Subject: Walnut Creek Energy Park - Docket No. 05-AFC-2C
Petition for Modification #6 - Electricity Generation Interconnection
Modifications

Petition for Modification No. 6

Modifications to the Electricity Generation Interconnection

Walnut Creek Energy Park

FIGURE 2
Project Site
 Walnut Creek Energy Park
 City of Industry, CA

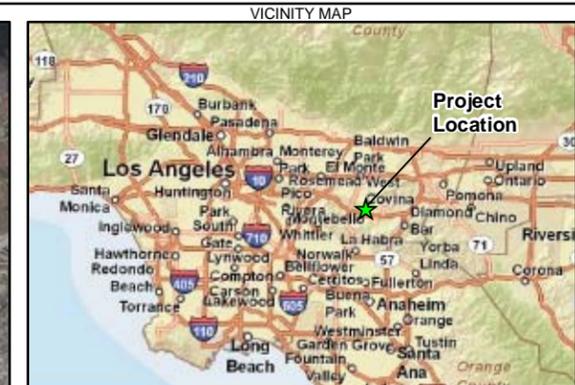
The additional areas (Figures 1 and 2) consist of two separate parcels (north and south) that are part of the existing SCE transmission line easements that are adjacent to the WCEP project site and the Walnut Substation. The two parcels are essentially vacant, with the exception of existing transmission structures, and are separated by the railroad tracks, which run east to west. These portions of the SCE easements were not anticipated to be needed for construction, and therefore were not included in the original Application for Certification (AFC) analysis.

FIGURE 1
WALNUT SUBSTATION
GEN-TIE MODIFICATIONS
 WALNUT CREEK ENERGY PARK
 CITY OF INDUSTRY, CALIFORNIA

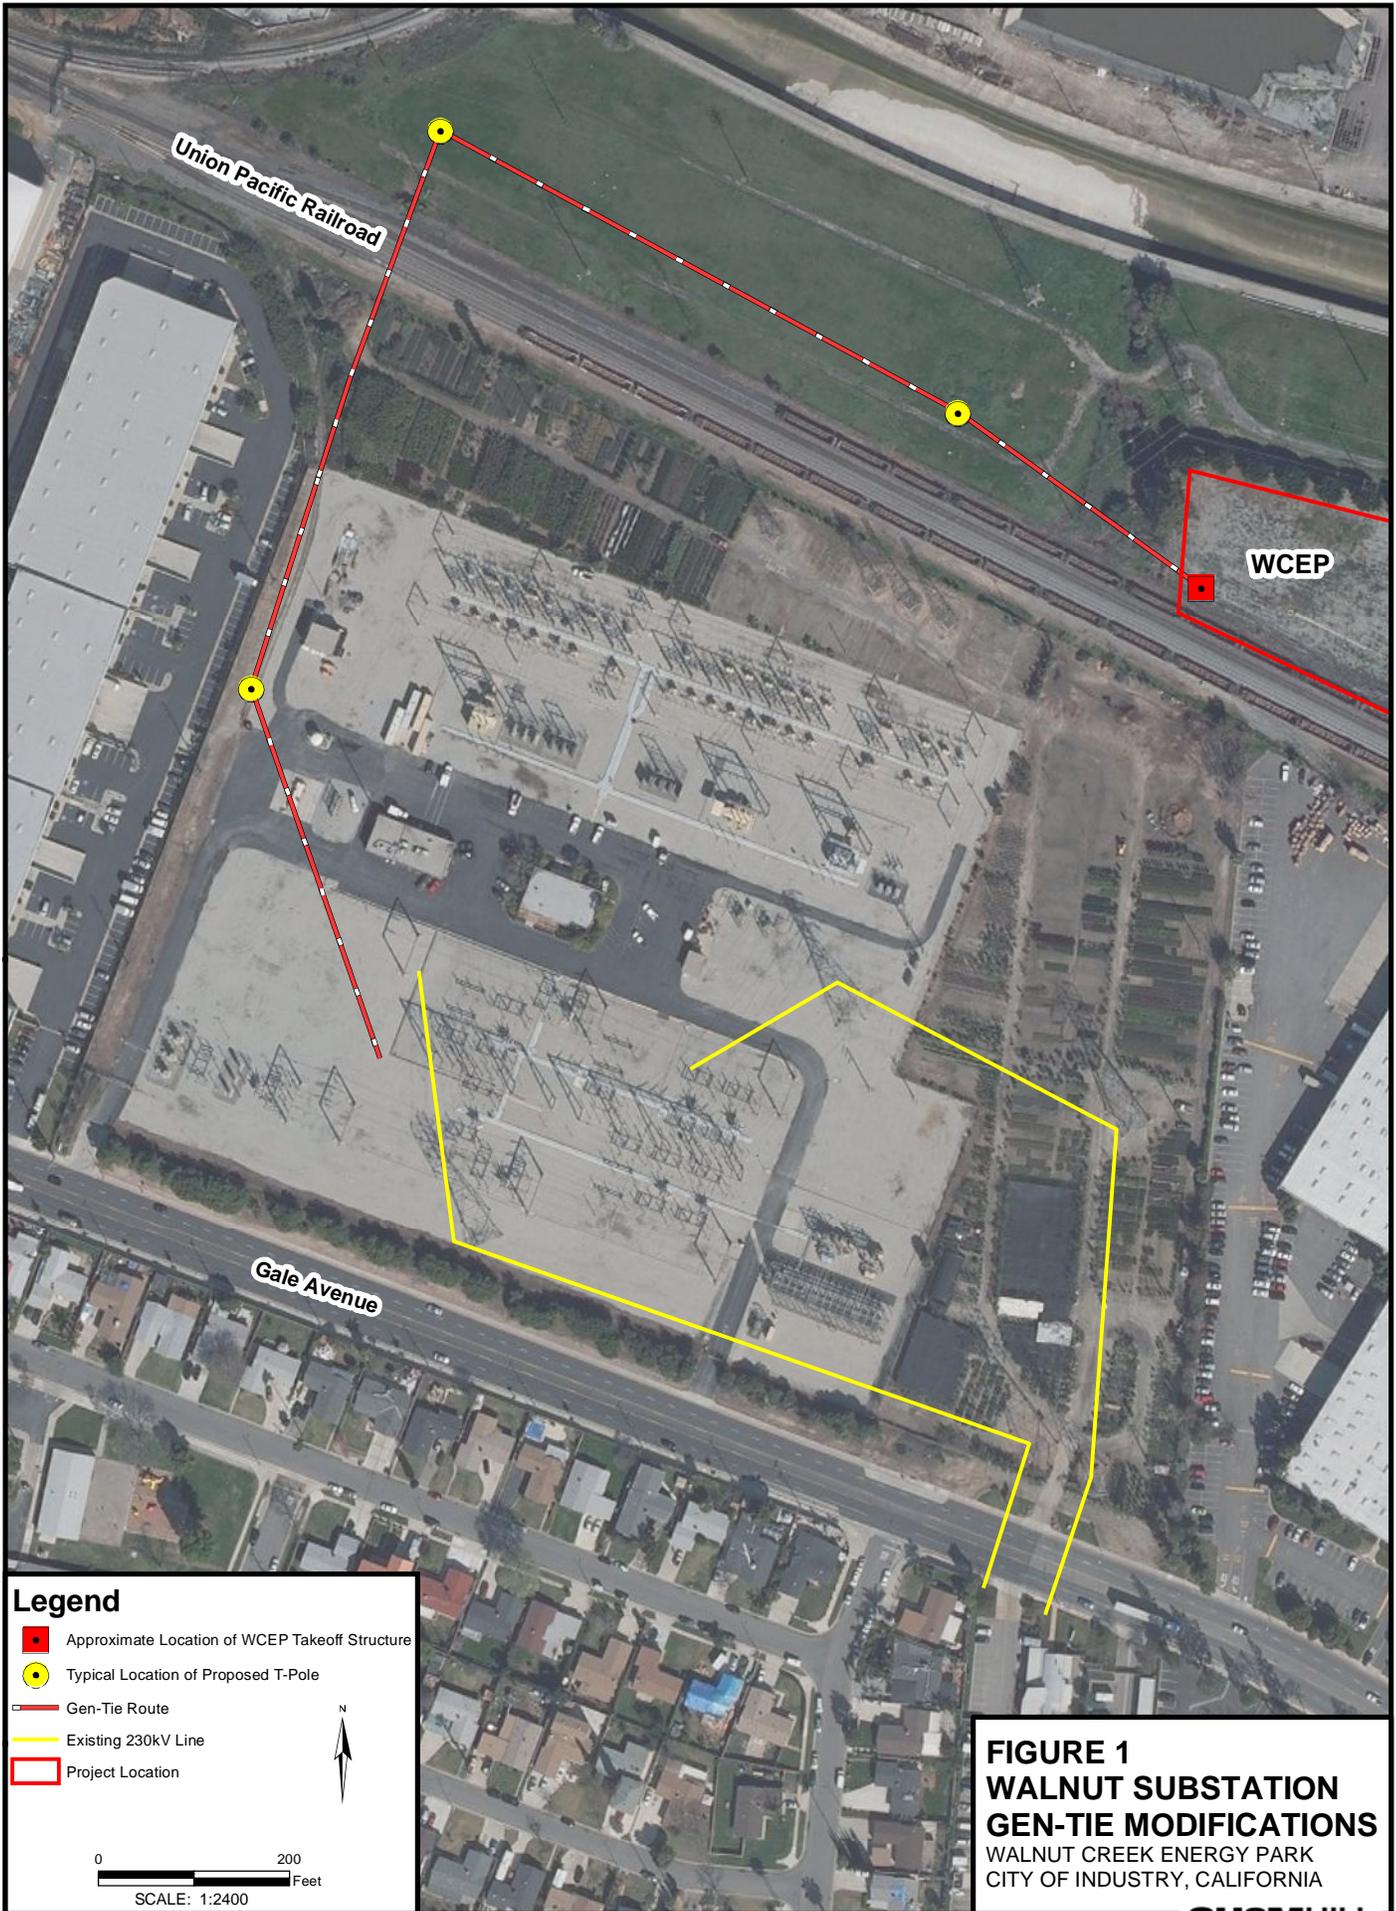
This Petition for Modification proposes the following modifications to the project description: (1) add two adjacent portions of Southern California Edison (SCE) transmission line easements to the project, (2) add related equipment modifications necessary to change the electricity generation interconnection structures (poles) configuration from a Delta arrangement to a Vertical arrangement, (3) reduce the number of offsite transmission poles from five to three, and increase their height from 135 feet to a maximum of 165 feet, and (4) change the height of one onsite transmission pole from 90 feet high to a maximum of 150 feet. These changes are necessary in order to keep the project's electricity generation interconnection, steel poles, crossarms and conductors inside SCE property, and to maintain a safe working distance from the conductor.

This Petition for Modification requests approval to add two new transmission construction areas to the original WCEP, as described in the Commission Decision. The purpose of the modification is to allow for modifications to the electricity generation interconnection arrangement accessing the nearby Walnut substation. The addition of the new areas will facilitate necessary changes to the project's generator tie-line to keep the steel poles,

crossarms and conductors inside SCE property, and to maintain a safe working distance from the conductor.
